# TECHNICAL SERVICE BULLETIN

## Hybrid - Rattle/Buzz Originating In The Right Rear Quarter Area - Built On Or Before 19-Jul-2021

21-2271

Ford 2020-2021 Escape
--------------------------

Figure 1

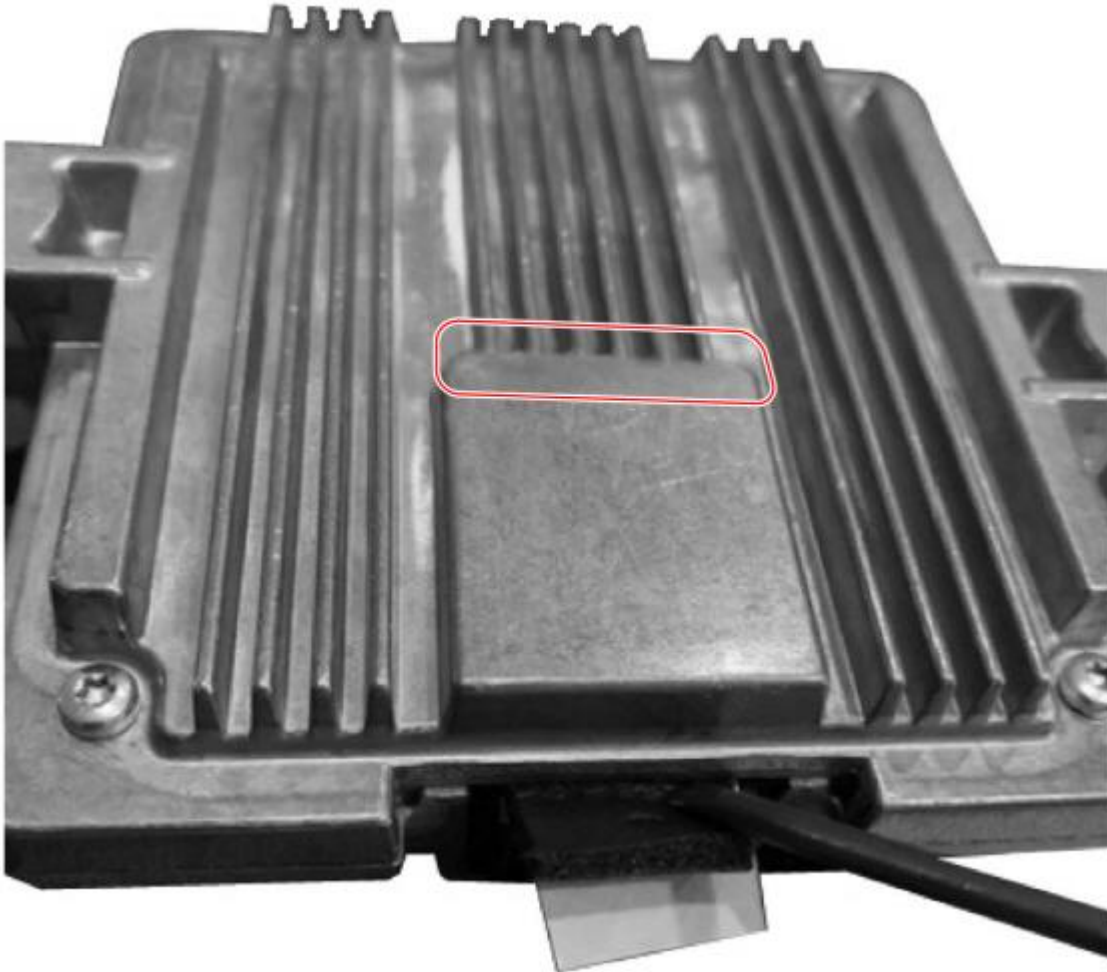
**NOTE: The connector's inboard side is attached to the printed circuit board of the module at the location indicated in Figure 1. This attachment provides some flexibility while working at the other end of the connector.**

Figure 2

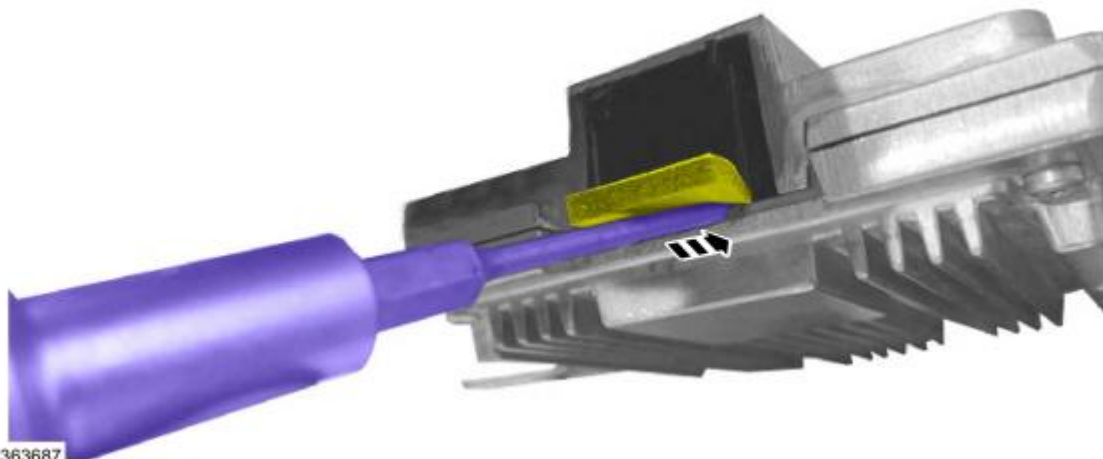
4. Fold the 1 inch (2.5 cm) squares over so that they are doubled in thickness.
5. Using a trim tool or small flat head screwdriver, insert the PVC foam in between the metal housing and the external facing internal connector. Insert the foam pieces between two sides of the connector to module case (Figures 2-3).
